Re: Floyd County PC FC-09-26-41 – Development Plan Review

DEVELOPMENT PLAN REVIEW BALLOT

Docket No.: **FC-09-26-41**

Docket Number: FC-09-26-41
Petitioner: Bryan Stumler Excavating
Location: 5895 Stiller Road, Floyds Knobs, Indiana
Request: Development Plan Review – Addition to prior Conditional Use FC-07-91-24
Zoning District: Rural Residential (RR)
Date: 10/14/2026

Drawing No.
C-101

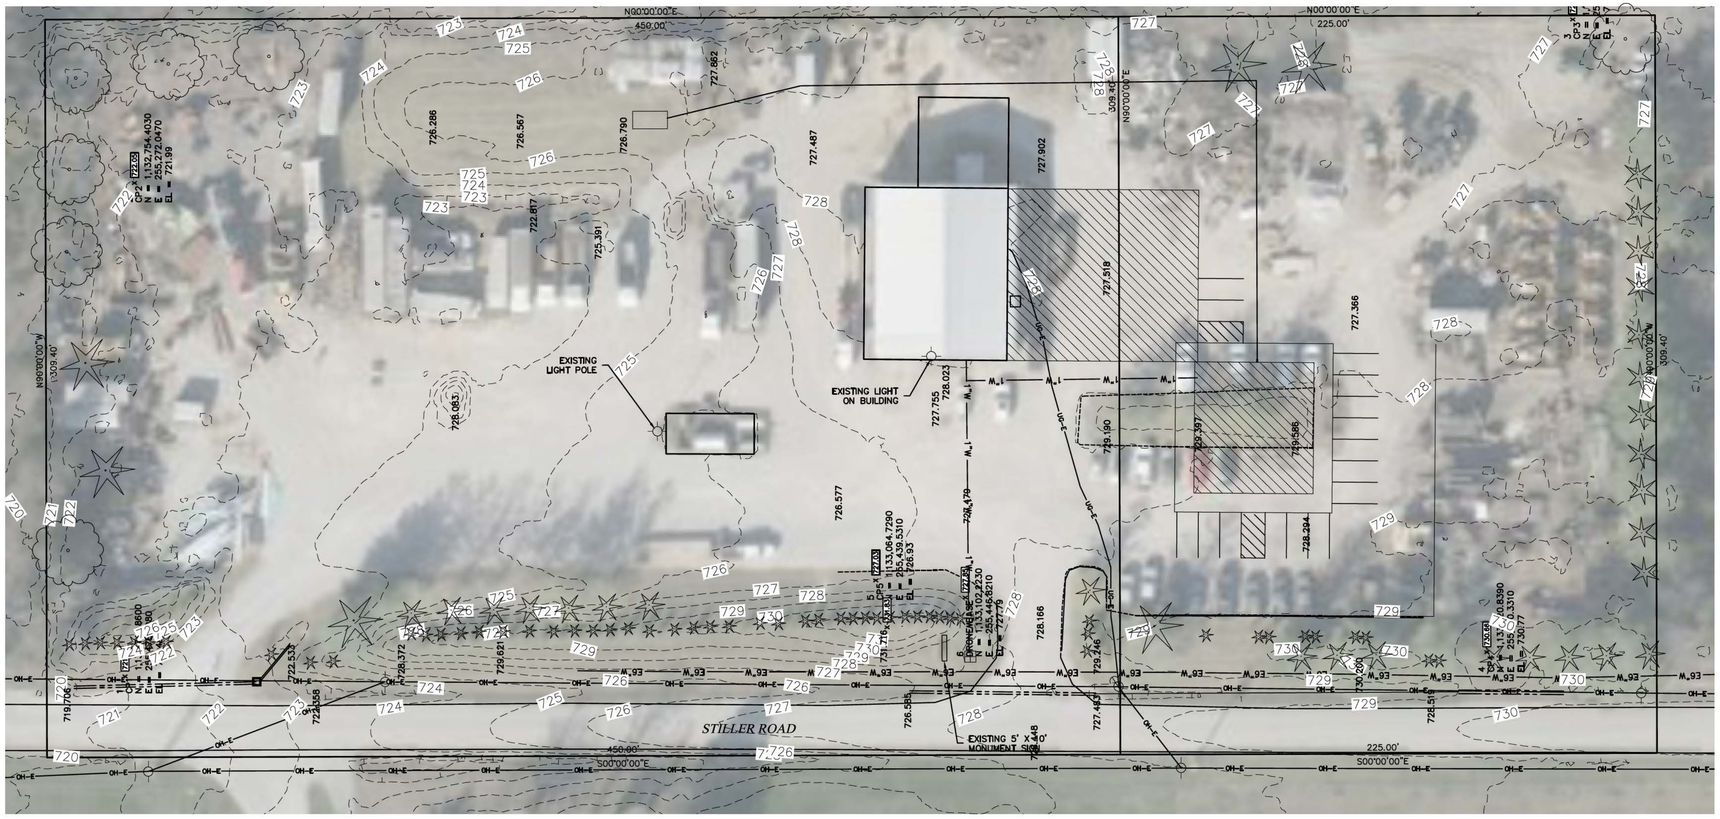
At this time, the existing site is not in compliance with its conditions.
FC-06-19-21 Item 1 – site appears to contain debris and junk no longer used.
FC-06-19-21 Item 5 – site not consistent with drawing presented at that meeting
FC-02-97-09 Item 2 – Drainage catch basin has been removed

- Parking lots were not in compliance (should contain 1 tree for every 8 parking spaces, rounded up).
- A buffer yard type II is missing from the rear and side property lines.
- Site is out of compliance with its missing retention pond, recommends submitting a drainage plan with a new retention pond location
- Southern entrance to the site is not paved, recommends a paved apron to prevent gravel and debris accumulating directly in the roadway
- With new structure, hydrants must be located roughly 450 feet from the building as part of fire suppression

- Applicant must obtain approval from the stormwater department for a drainage plan and retention basin, which shall be replaced on the site.
- The southern entrance shall be paved with an apron running 30’ back, so as to reduce gravel and debris entering the public roadway.
- A buffer yard of 15’ shall be added to the sides and rear of the property, within which shall be placed either a fence or wall at 6’ in height or a living fence of evergreen trees or shrubs with an adult height of at least 6’ and planted no more than 12 feet apart.
